Addendum #1

Question and Answer

RFP No. UOT202517330

History Admin. Offices Refresh 2nd Floor - Reconstruction

Drawing Sheet Title
PARTITION PLAN

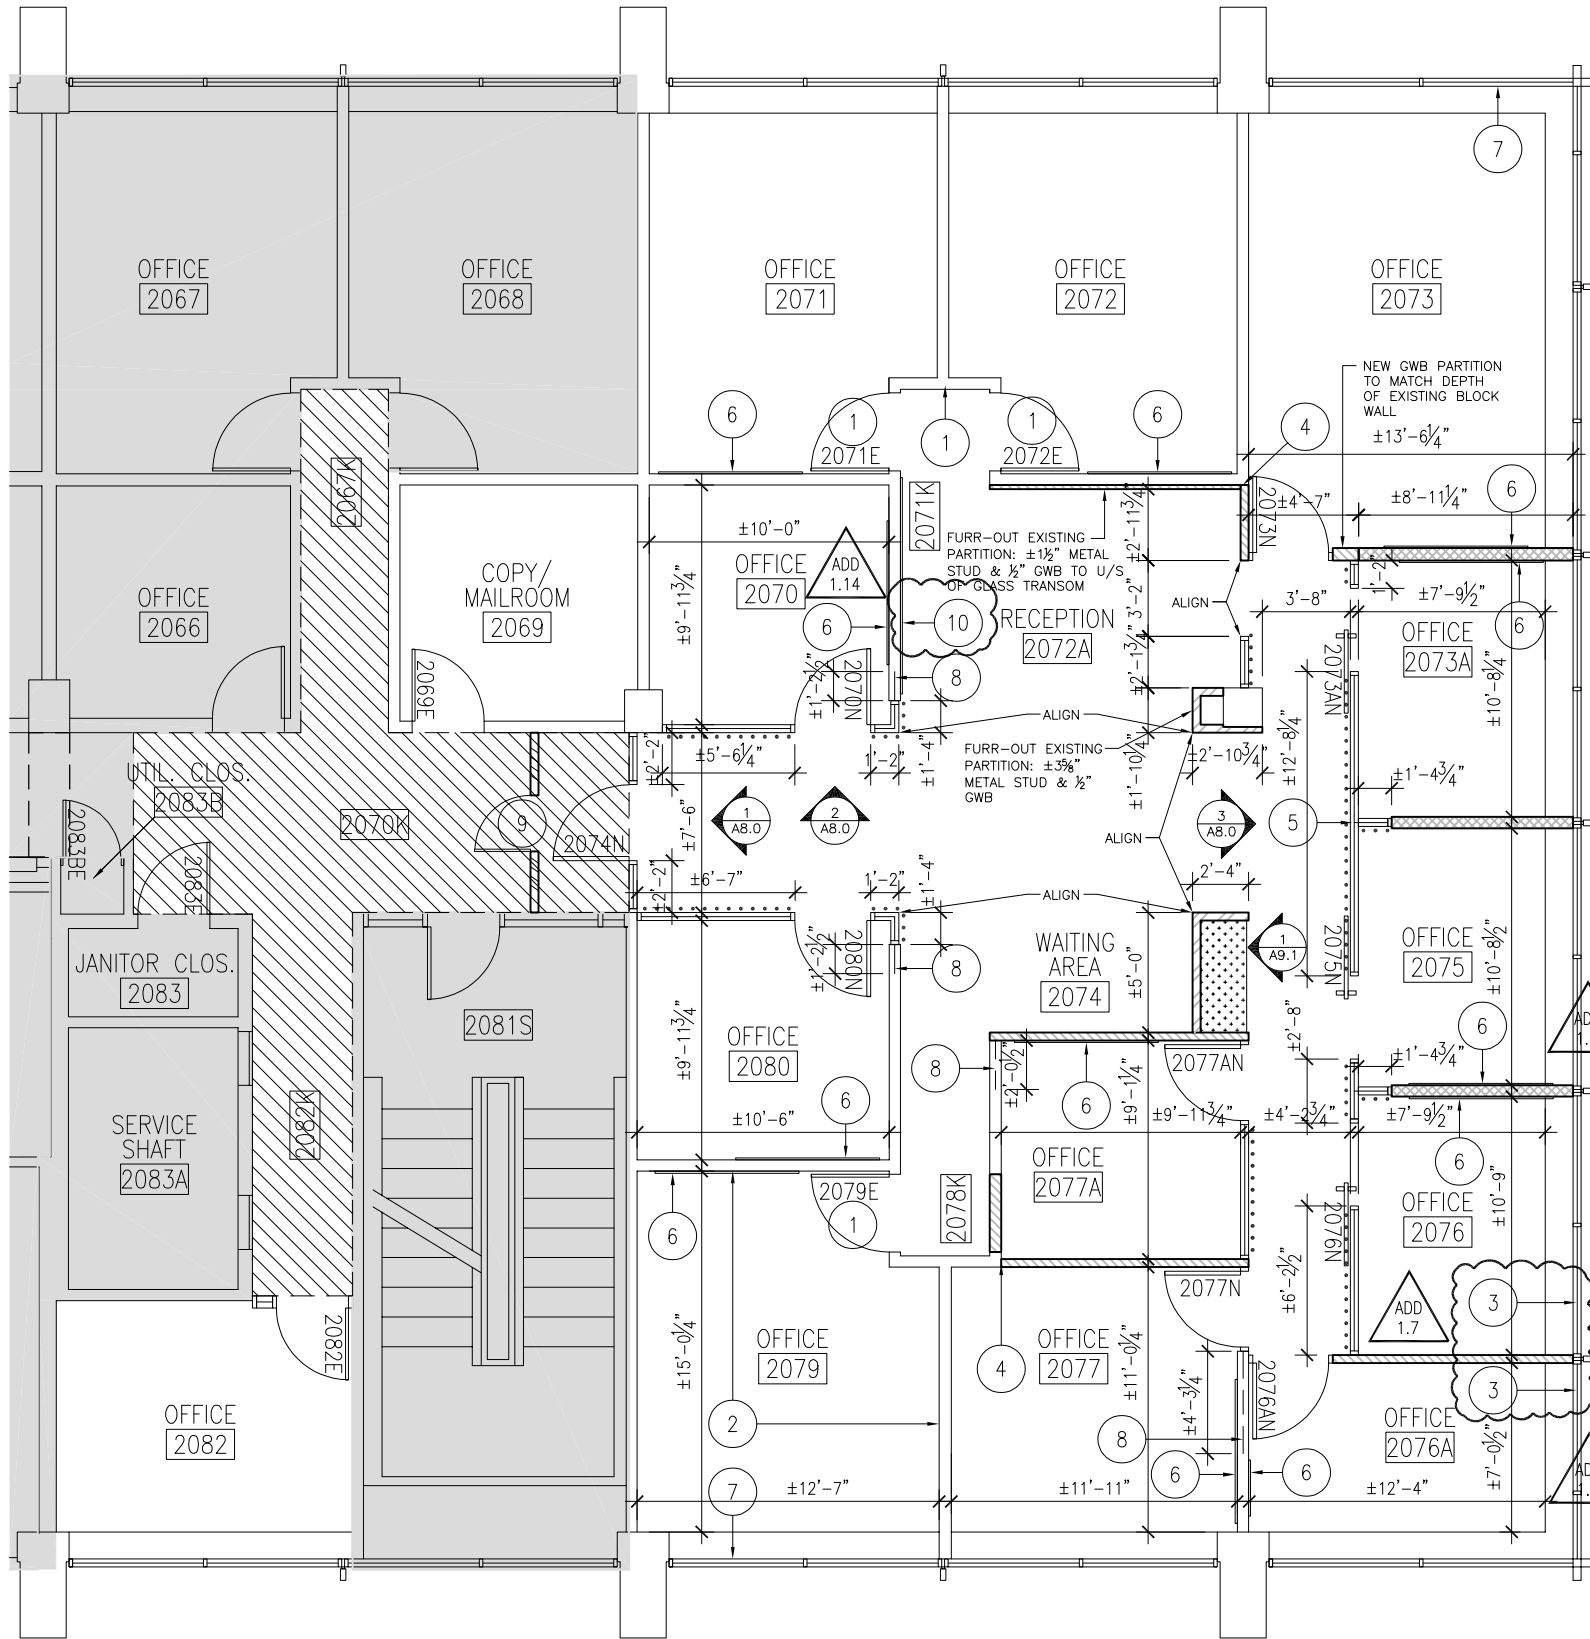
- Qty. of 12 new magnetic glass boards, 74" x 41", to be modified to qty of 11. Refer to note #6 on attached Partition Plan A2.1.
- Contractor to reinstall existing 9'-0" x 5'-8" magnetic glass board, stored in room 2091, in reception area. Refer to note #10 on attached Partition Plan A2.1 for location.
- Contractor to install new patch panel, above existing switch in room 2092, and terminate all new cables (total 30) to new patch panel. Refer to attached Power & Data Plan A4.0 for further details.

No.	Question	University Response
7	Please confirm the locations where roller blinds/Pull chain requires repair and provide the specification of roller shades?	<p>2 existing blinds need to be disposed of and replaced with new: one in room 2076; and one in room 2076A. Refer to Note #3 on attached Partition Plan A2.1 for exact locations. 2 existing blinds need to be repaired: one in room 2073 and one in room 2079. Refer to Note #7 on attached Partition Plan A2.1 for exact locations.</p> <p>Refer to Finishes Plan A6.0 for new window blind specification WC.1</p>
8	Please confirm the distance from the ceiling to the deck above.	Plenum height is ~54".
9	Please confirm if there is a base building contractor for controls.	Non applicable
10	General note calls for the re-insulation of existing supply air duct and heating piping but they are not shown on the drawing. Please confirm the quantity of insulation required or the drawings for both services to be re-insulated. Considering the cash allowance, it indicates only piping insulation. Please advise for the ducting re-insulation.	There is a cash allowance on bid sheet for this. Once GC is selected, the site will be reviewed and the GC will provide an updated cost for this.

- 6 CONTRACTOR TO SUPPLY AND INSTALL NEW MAGNETIC GLASS WHITEBOARD AND PROVIDE BLOCKING AS REQUIRED. ALL BOARDS TO BE MOUNTED 38" AFF. GC TO CONFIRM FINAL LOCATIONS WITH DESIGNER.
MAN.: QUARTET BY GRAND & TOY
PRODUCT: INVISAMOUNT MAGNETIC GLASS DRY-ERASE BOARD, WHITE TEMPERED GLASS SURFACE. EACH BOARD COMES WITH 1 X MARKER TRAY; 1 X DRY ERASE MARKER; 2 X ROUND MAGNETS
MODEL/DIMENSIONS: MODEL #22332-0; 74"W X 41"H; QTY. 1 (RM 2070, 2071, 2072, 2073, 2073A, 2075, 2076, 2077, 2077A, 2079, 2080) AND MODEL #22331-0; 28"W X 49.7"H; QTY. 1 (RM 2076A)

- 10 CONTRACTOR TO REINSTALL EXISTING 9'-0" X 5'-8" GLASSBOARD, STORED IN RM 2091. PROVIDE BLOCKING AS REQUIRED. CONFIRM FINAL LOCATION WITH DESIGNER.

FINISHES PLAN

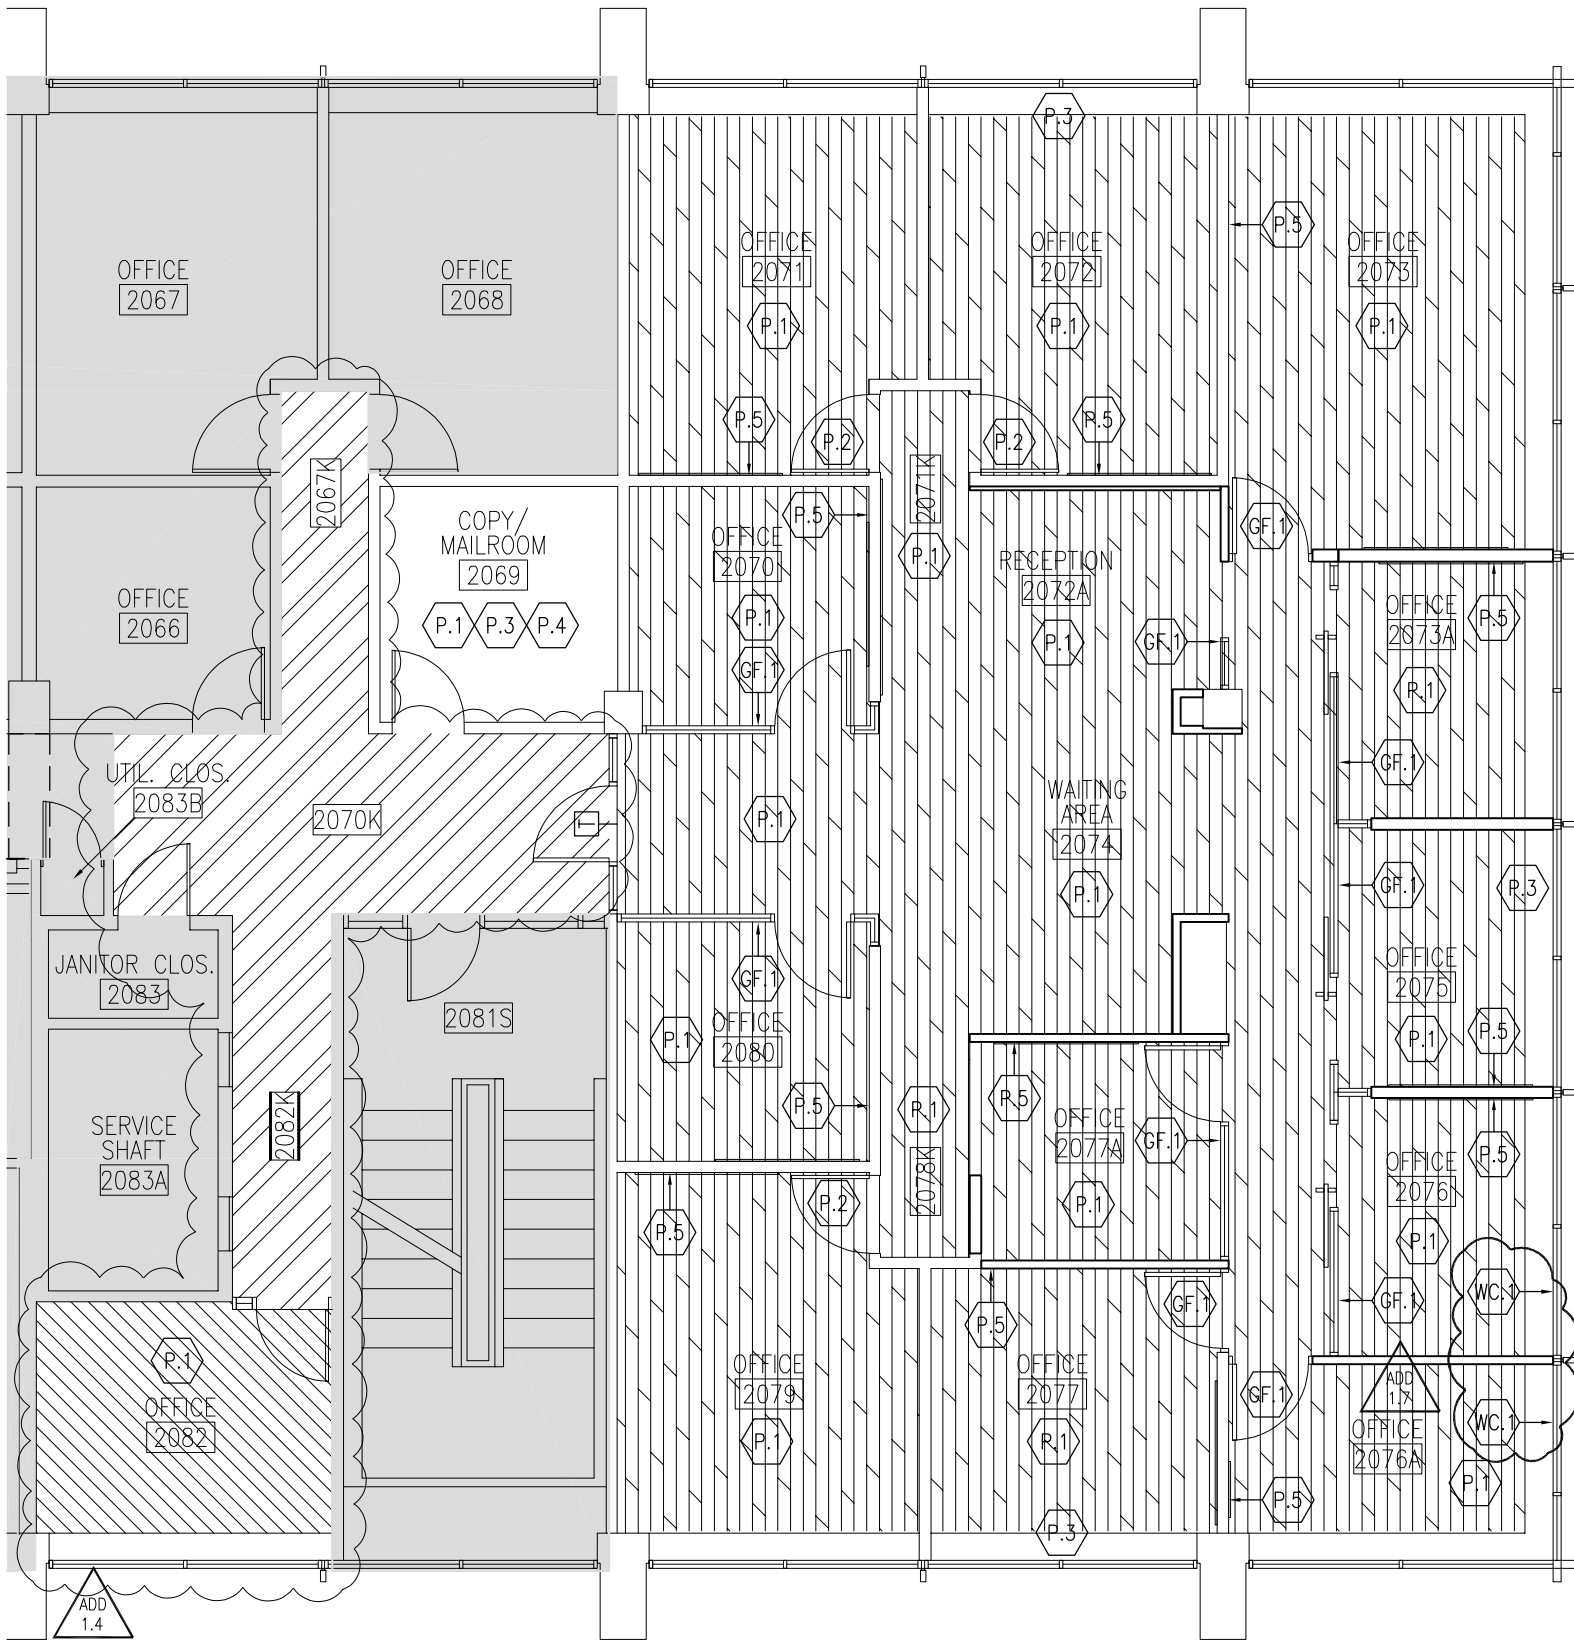
No.	Question	University Response
3	Please provide clarification on any work preformed by the GC's own forces or sub trades as it relates to local 27. Does all work covered by local 27 need to be completed by unionized local 27 forces regardless of contract amount?	The University cannot provide legal advice on the GLCs. Contractors are best suited to determine whether a particular scope of work involves the use of unionized labour as well as the application of the labour agreement
4	Please provide specification for existing VCT confirming the Manufacturer and product name.	<p>Man.: Armstrong Product: Excelon VCT, 12" x 12" Colour: TBD</p> <p>Refer to attached Finishes Plan A6.0 for locations.</p>
5	Is the corridor 2067K, 2070K, 2082K, 2082 are only part of separate price or need to cover in base bid price too? If yes, then in base bid price scope what are the finishes for these areas, will it be LVT same as rest of the scope?	<p>Corridors 2067K, 2070K and 2082K are the only floors that need to be a separate price for demo, supply and install of new, included in the tender (refer to update bid price schedule under separate pricing). Refer to Partition Plan A2.1 for demolition locations.</p> <p>Refer to attached Finishes Plan A6.0 for flooring specifications for 2067K, 2070K, 2082K and 2082.</p>

WINDOW COVERING
MANUFACTURER: PHIFER SHEERWEAVE (OR APPROVED ALTERNATE)
STYLE: 4400, 3% OPEN, MANUAL
COLOUR: TBD (TO MATCH EXISTING)
FASCIA: 4" ANODIZED ALUMINUM
SIZE: 2 @ ±5'-5"W x ±7'-1"H. ALL DIMENSIONS TO BE SITE VERIFIED.
NOTE: PROVIDE 4" ALUMINUM FASCIA, LOWER BOTTOM BAR & STAINLESS BALL CHAIN. PROVIDE BLOCKING AS REQUIRED.
